**Internal procedures for Solar Keymark WP1.A
and input to CEN/TC 312**

**Version: 3
2003-03-20**

Solar Keymark
WP1.A
Network for implementing standards
Solar Collectors

Right Figure 5

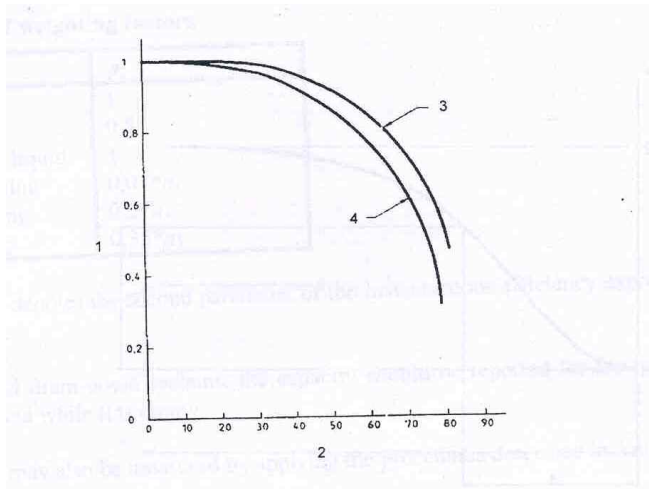
Comment 16: Illustrations

In 6.1.7.1 the Figure 5 is wrong figure and should be the one shown below.

Right Figure I.3

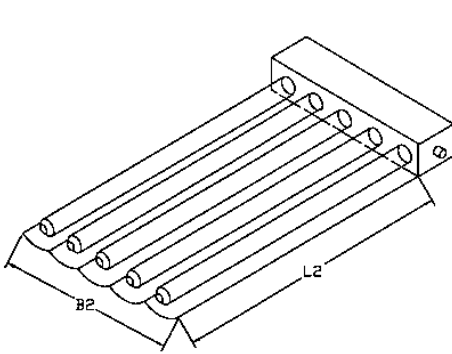
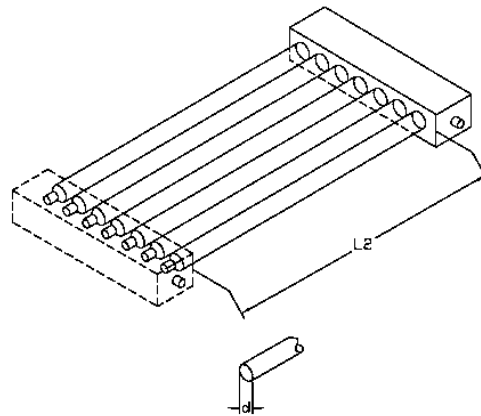
Comment 17: Illustrations

In Annex I the Figure I.3 is wrong figure and should be the one shown below.

Right Figure I.5

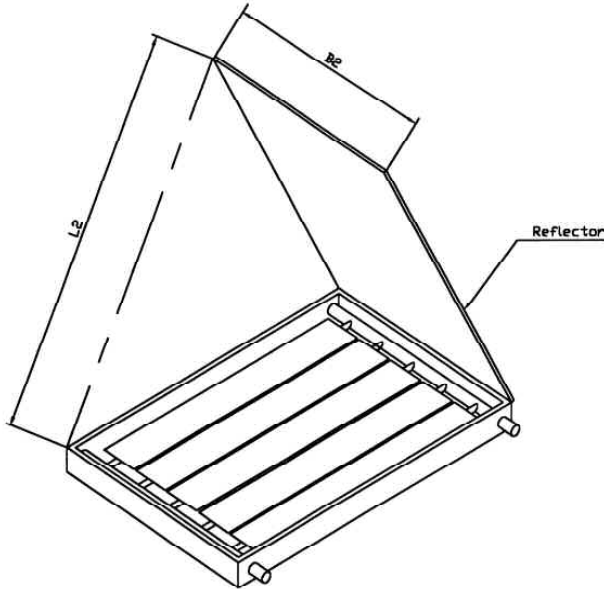
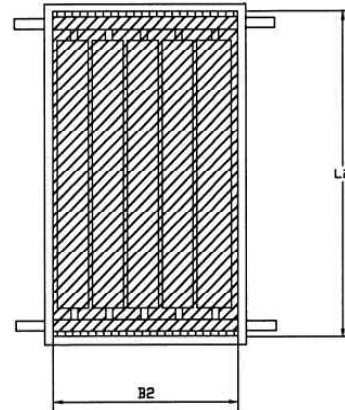
Comment 18: Illustrations

In Annex I the Figure I.5 is wrong figure and should be the one shown below.
